Subject: Mauna Lahilahi Beach Park – Rock Revetment

Project Name: Mauna Lahilahi Beach Park Rock Revetment

APPENDIX D: Comment Letters and Responses

**Figure 3-1 (a) Mauna Lahilahi Cove Beach in 1970, (b) Topographic Map in 1972
(Division of Land Survey & Acquisition);**

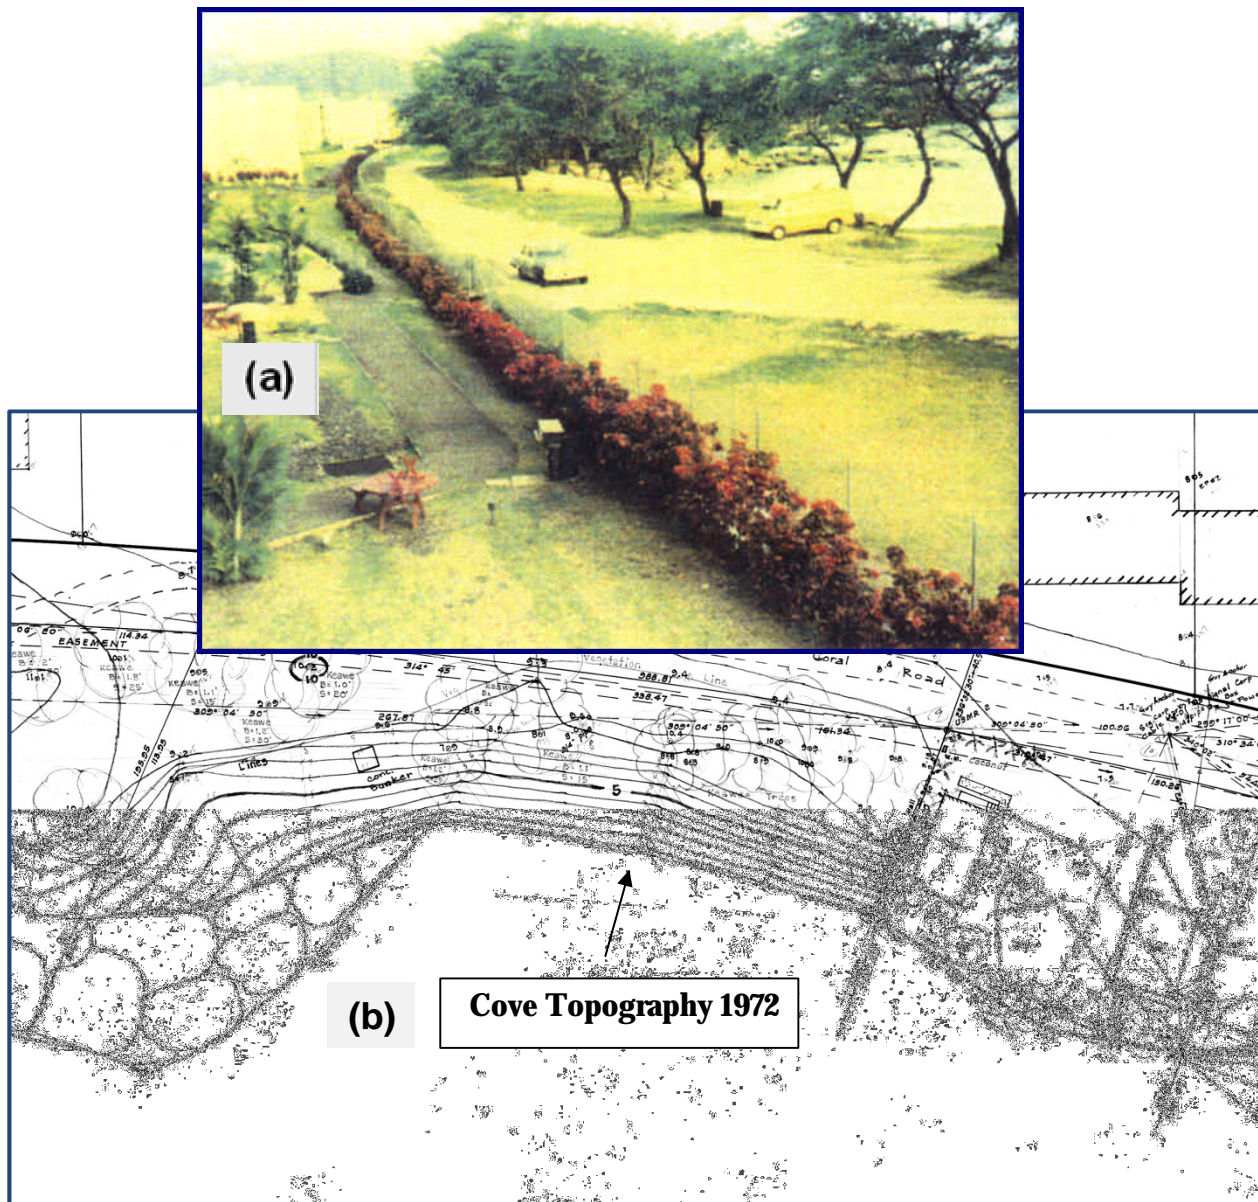
1. *Figure 3-1b is difficult to read. If it is intended to show the topographic conditions that existed in 1972, a more legible plan should be provided.*

Figure 3-1b has been edited to more clearly show the topography and beach slope in 1972. The edited version will be used in the Final Environmental Assessment (FEA).

Figure 3-12. Proposed Revetment Plan

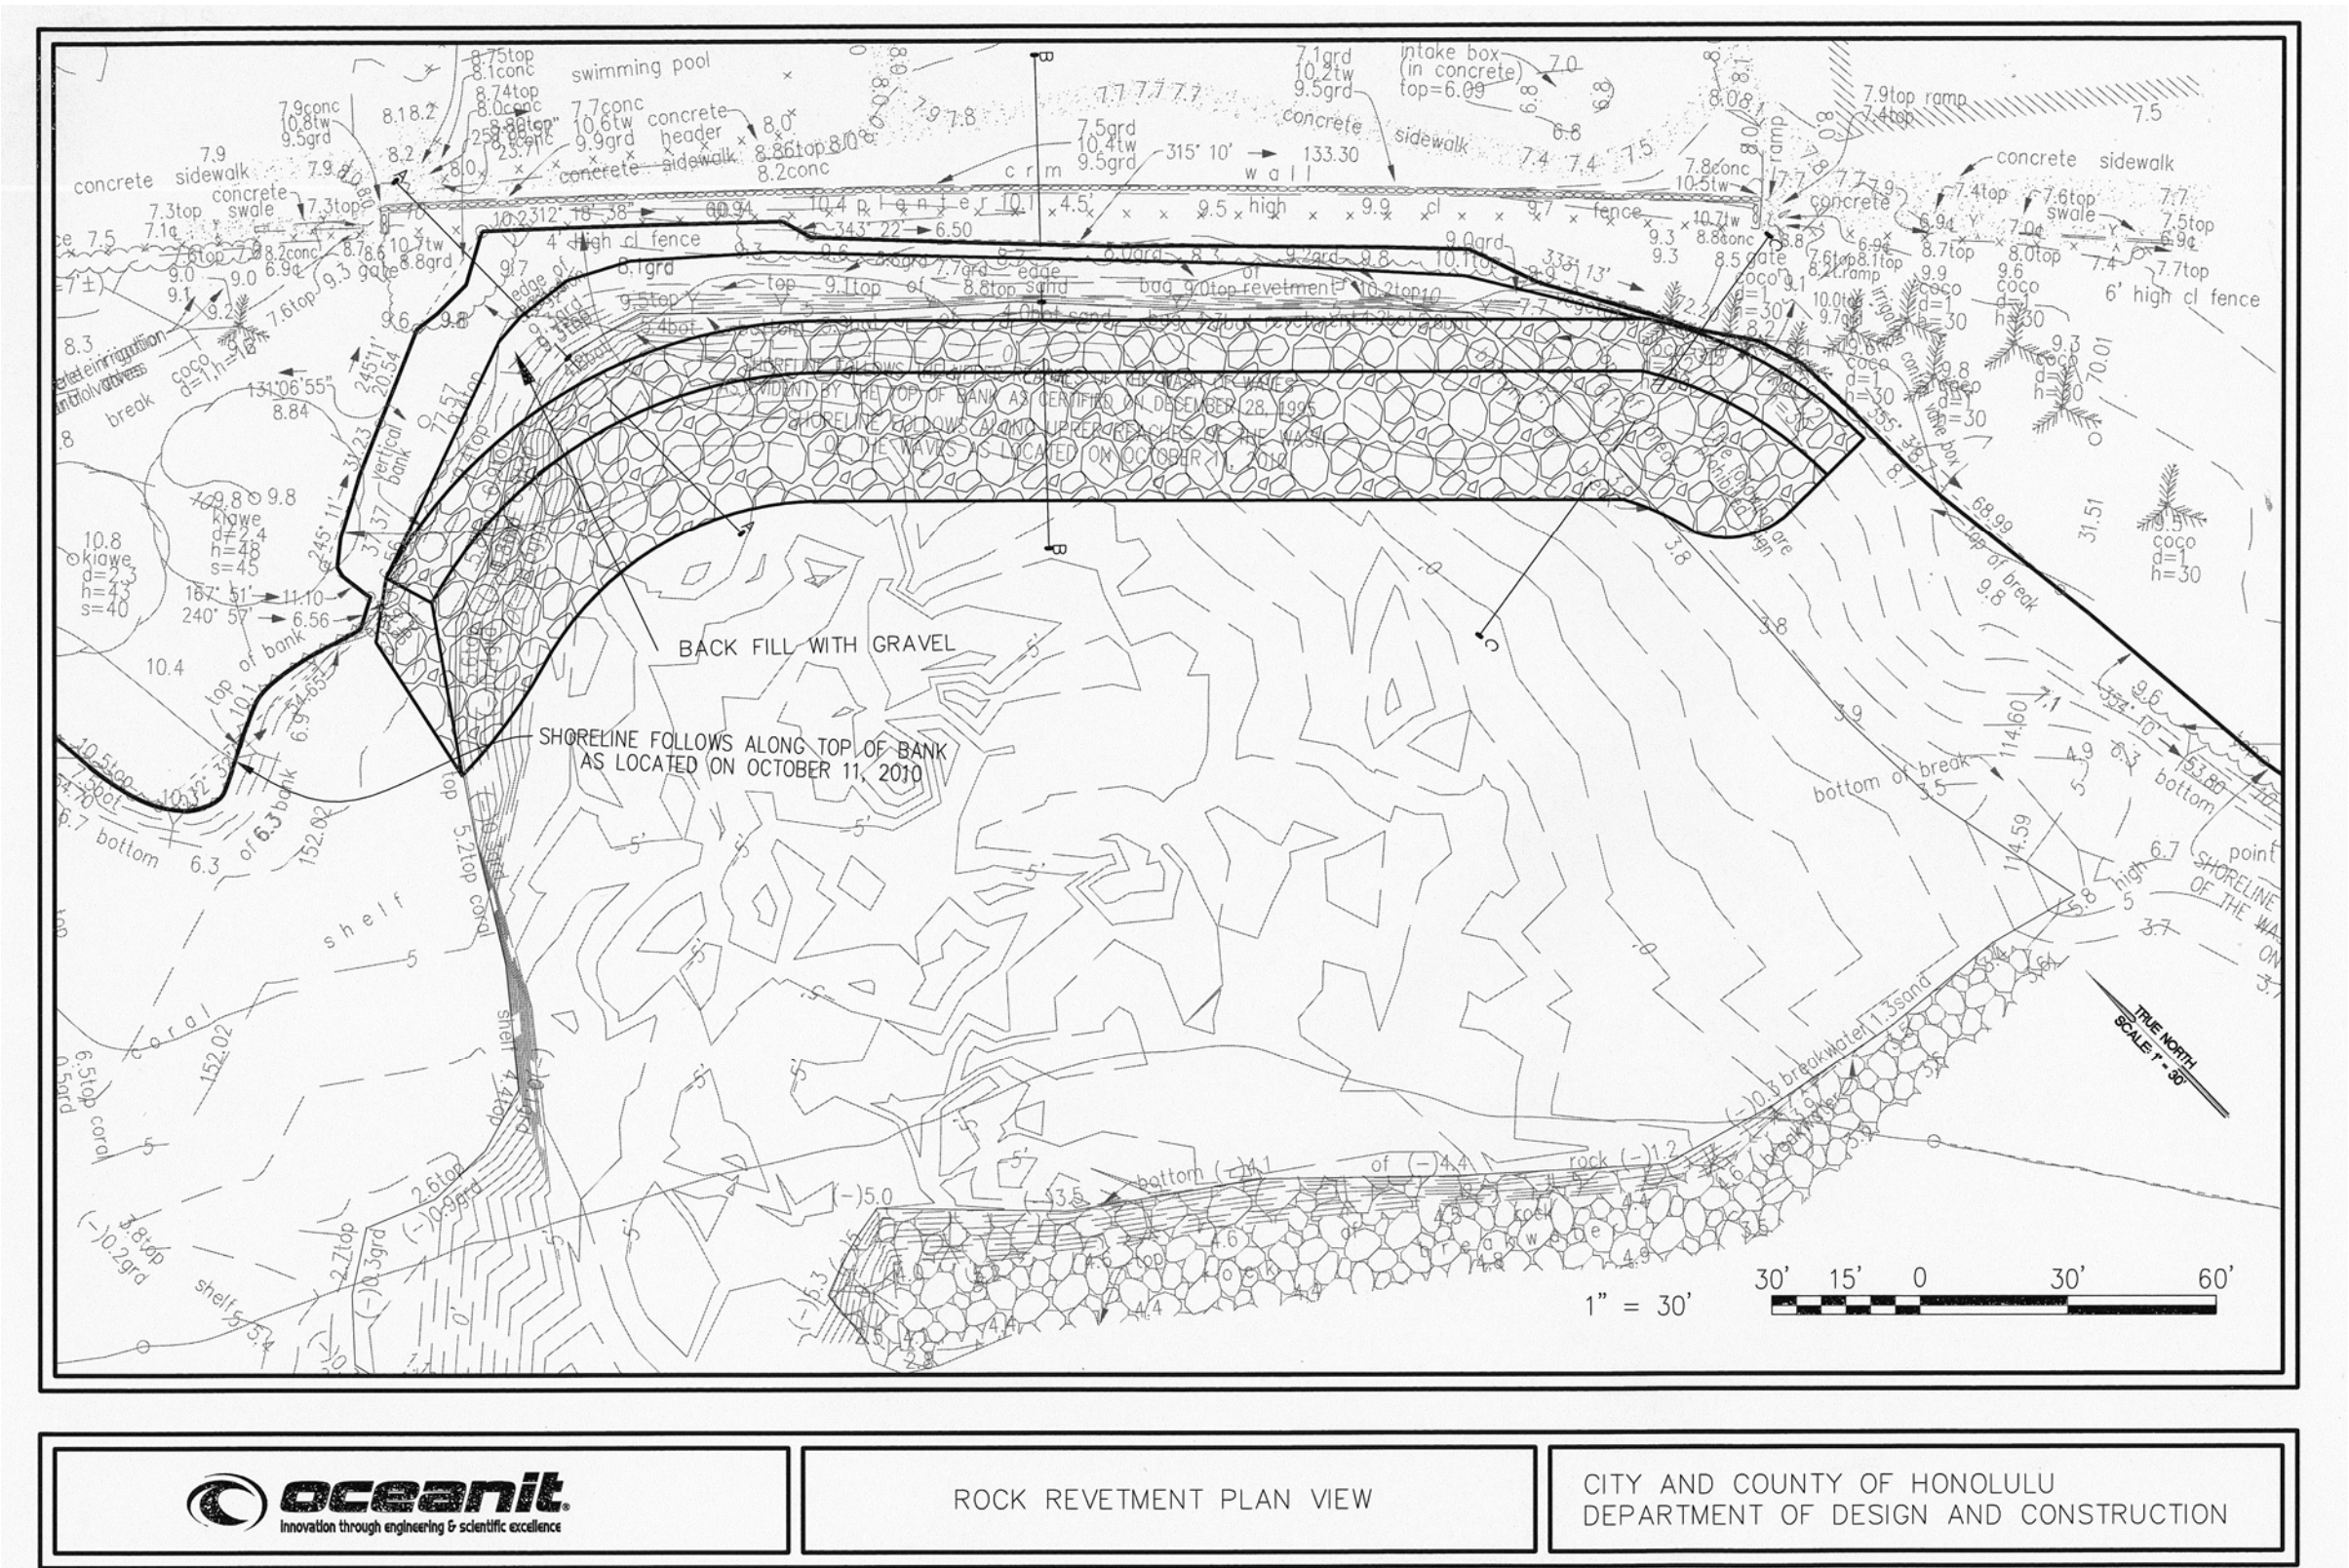
2. *Include the dimensions of the revetment on Figure 3-12 Revetment Plan.*

Based on the Rock Revetment Plan View (Figure 3-12) and Rock Revetment Cross Sections (Figure 3-13) in the Draft EA, it appears that the Revetment will have a cross section width of between 40 and 60 feet, including the gravel backfill area. OCCL suggests adding description and consideration of alternative erosion control structure designs with reduced footprints compared to the preferred alternative in the Final EA. A reduced footprint will reduce impacts to the marine substrate and maximize the usable space for recreation (e.g., swimming, canoe launching) within the cove. Additional alternatives that OCCL would like to see considered and discussed in the Final EA include a vertical seawall and a hybrid seawall/revetment structure, as well as designs not including substantial backfill (e.g., build a structure against the existing erosion scarp).

Figure 3-12 has a graphic scale because it is too busy to show dimensions clearly. The revetment armor stone layer is approximately 300 feet long and 40 feet wide.

Figure 3-13. Proposed Revetment Cross Section

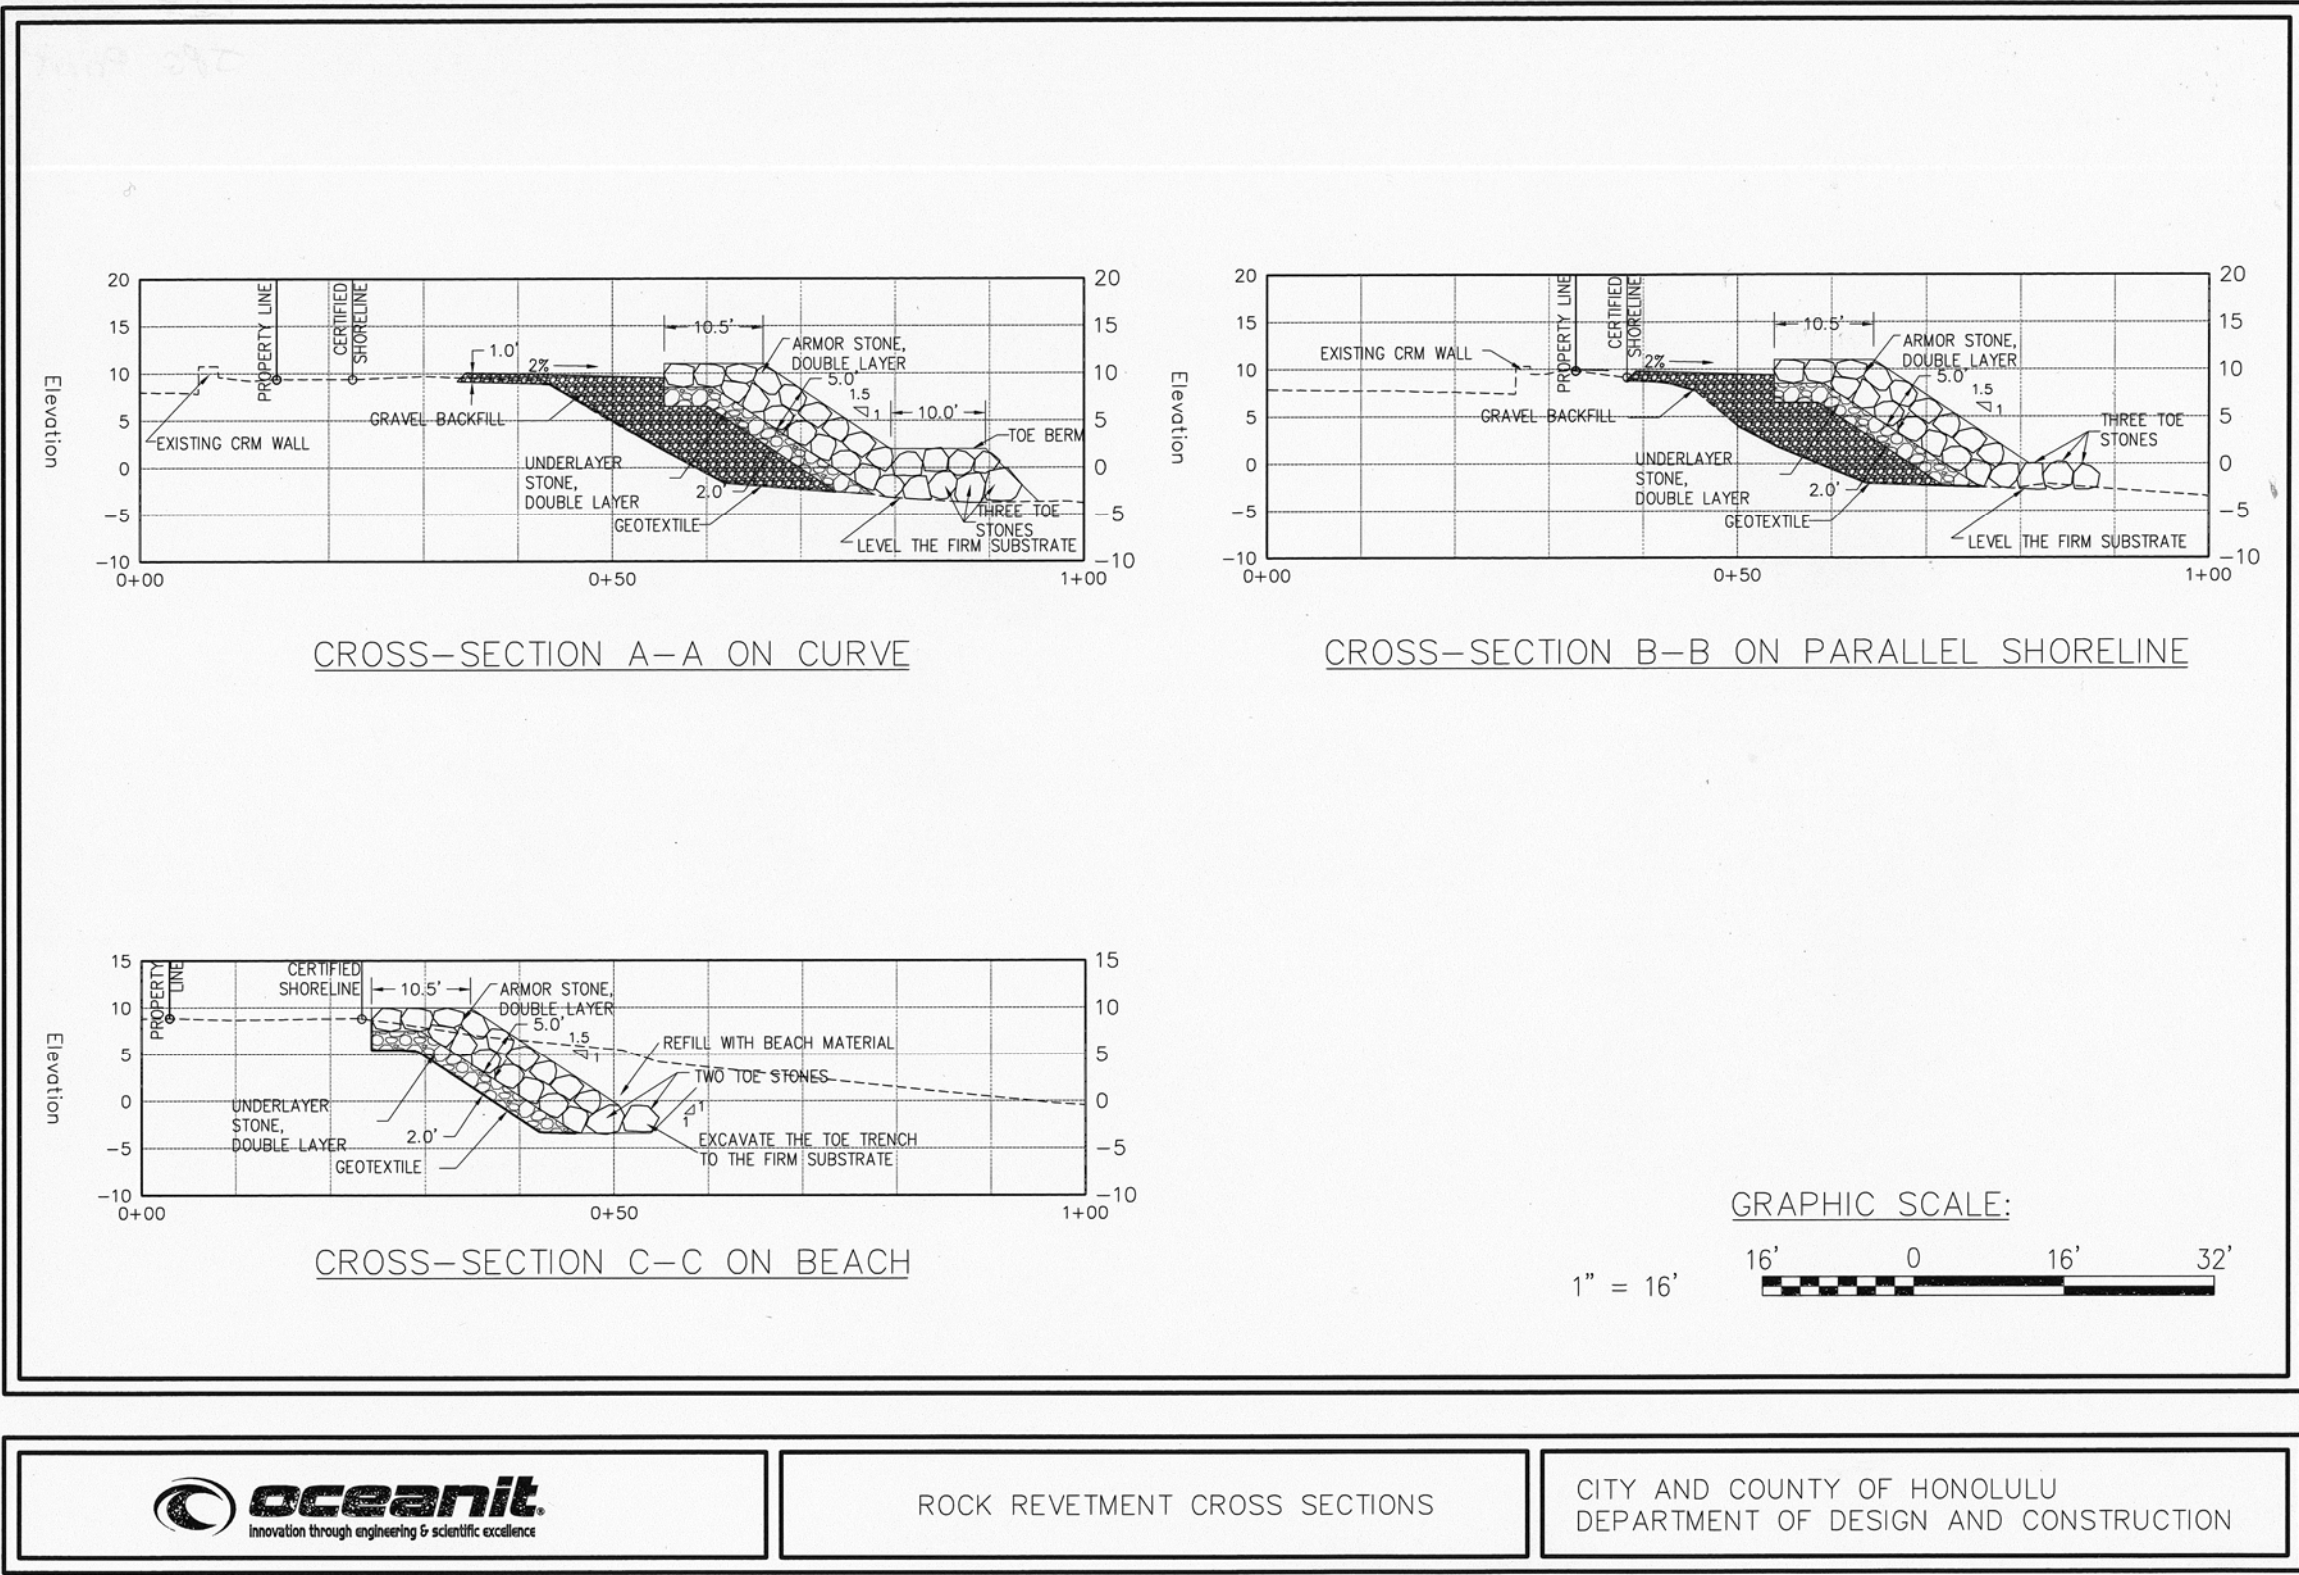
Please include the spatial dimensions of the proposed Revetment design including length, width, height, footprint area, and elevations above tidal datum. For comparison, please provide dimensions of the existing sandbag and rock revetment.
